Sent: 25/10/2022 10:53:51 AM
Subject: Submission - issues of concern with proposed development at 9 Kananook Avenue BAYVIEW
Attachments: STAMPED_MODIFIED_CONSENT_PLANS_N0199_04_-_KNICOL_PTY_LTD.pdf; First Floor Plan Mark-Up.pdf;

Application No. DA2022/1586

Address: Lot 31 DP 11423 9 Kananook Avenue BAYVIEW

Regards

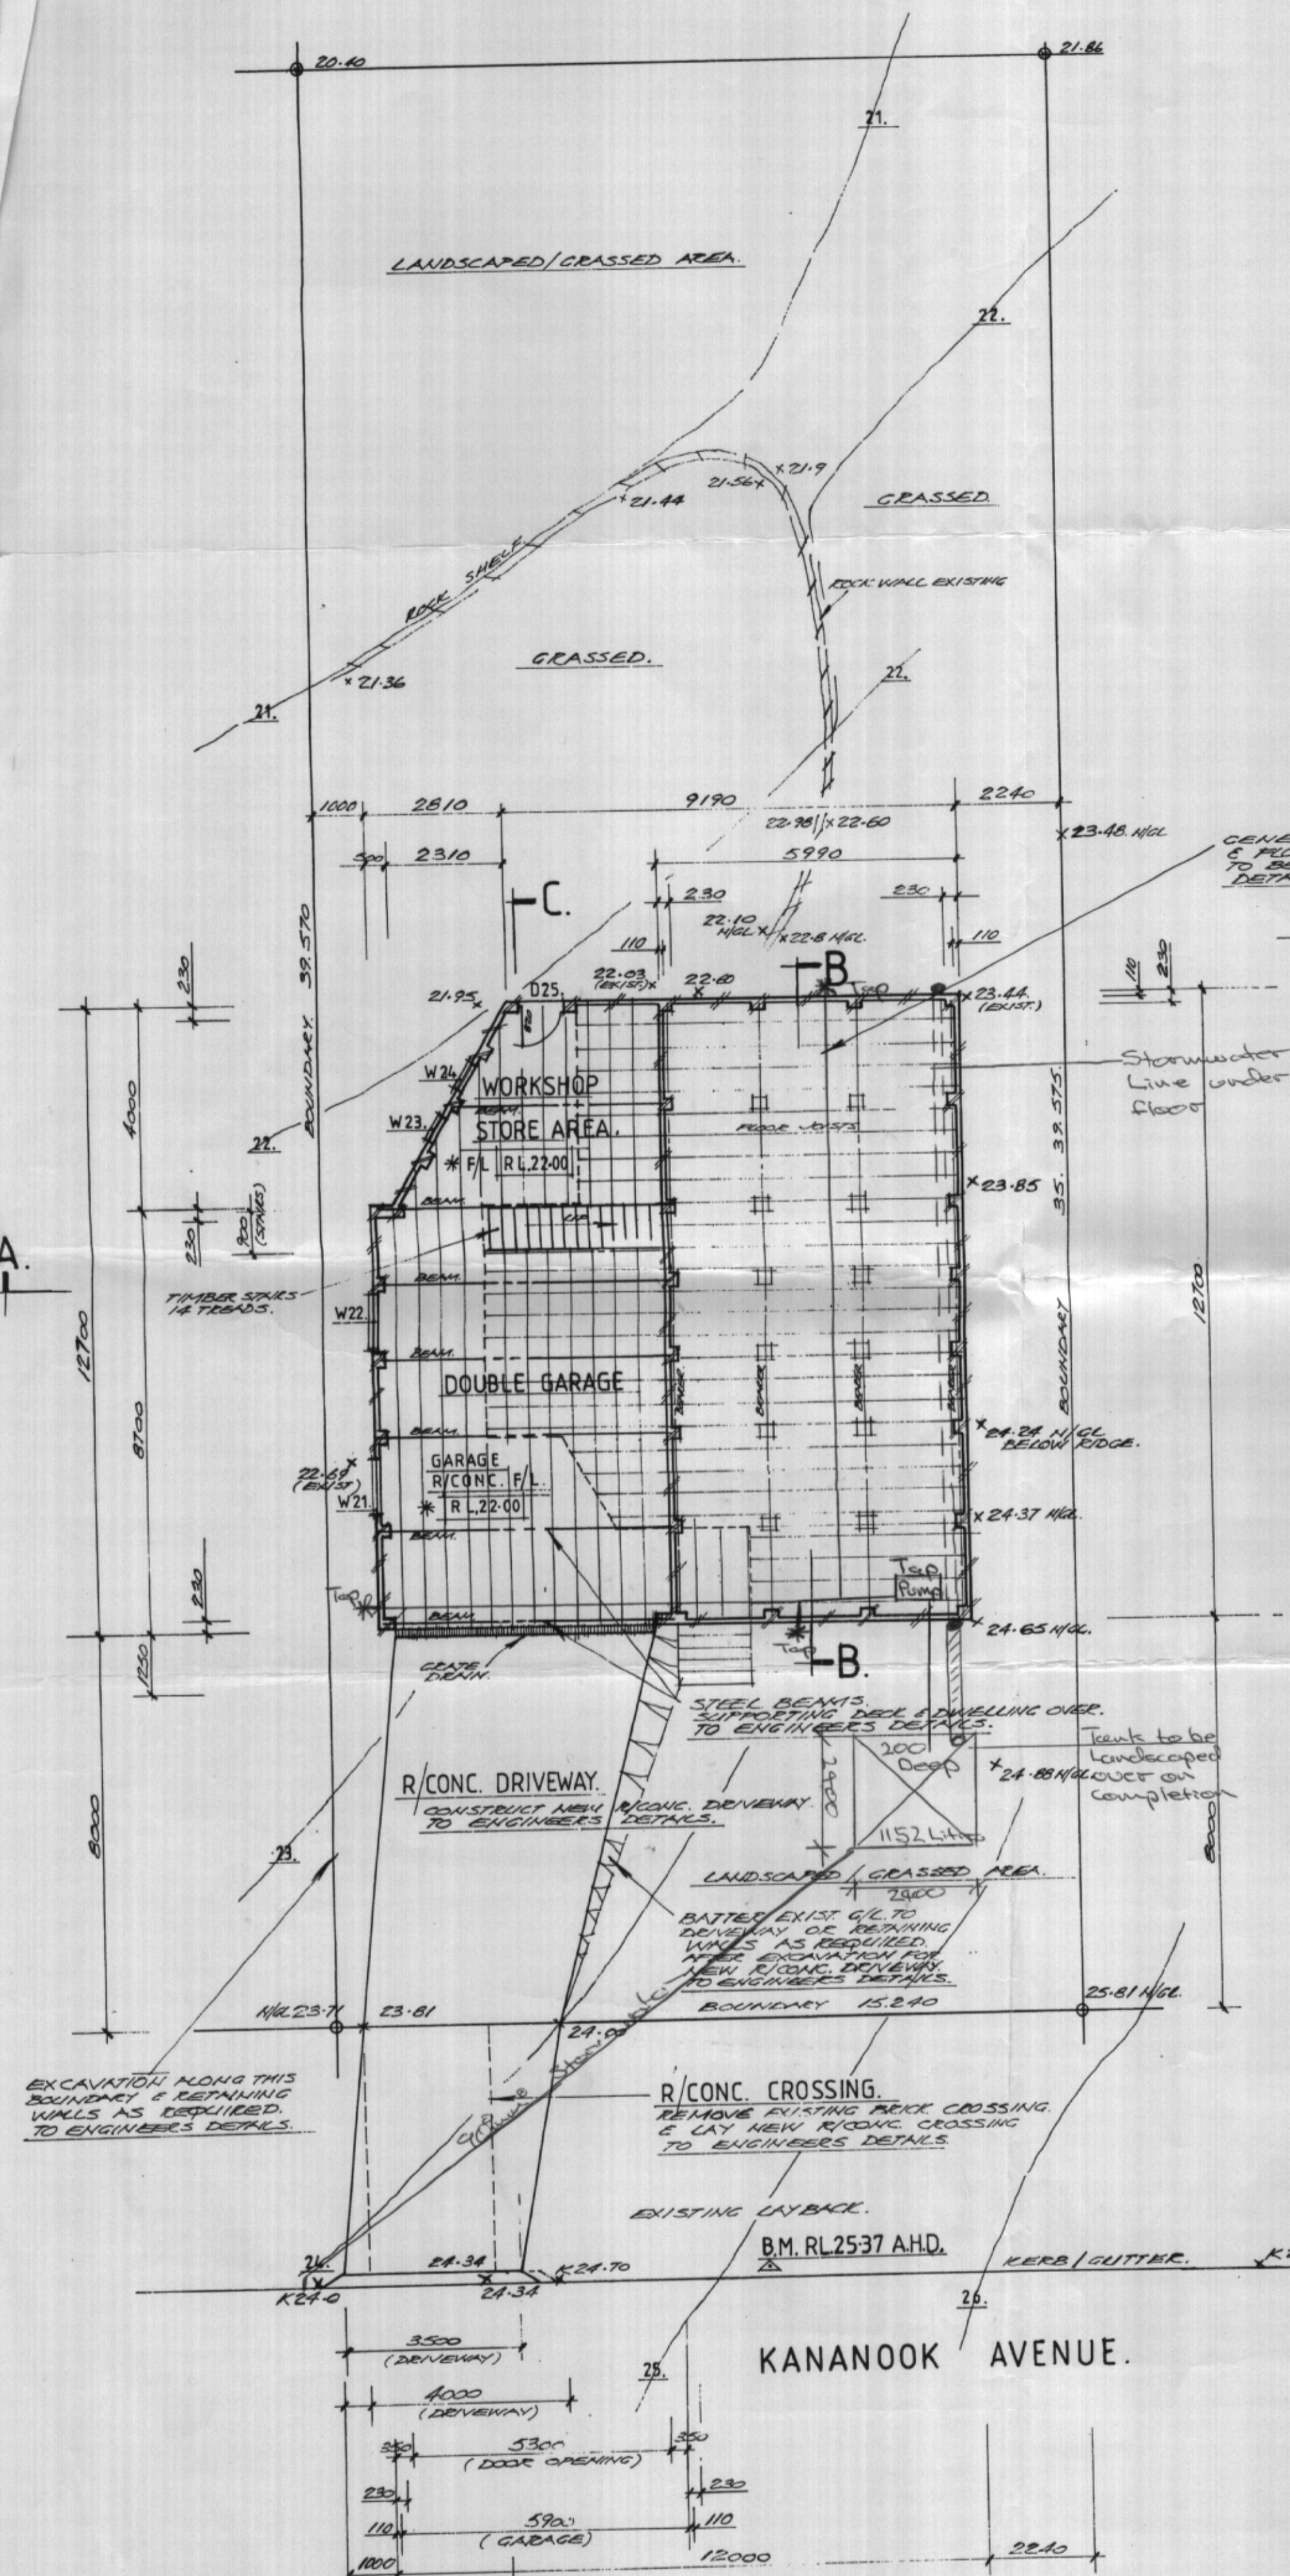
The Existing First Floor Plan and the Demolition First Floor Plan incorrectly identify the footprint of the existing upper floor deck.

As the Proposed First Floor Plan is superimposed on the Survey, the outline of the upper balcony is visible on the plans. The approximate outline of the existing first floor balcony is highlighted in green on the attached marked-up plan, with the area in yellow being the portion of the deck that we believe should be identified as proposed new works. This also translates to the elevations and sections which are also inconsistent in this regard.
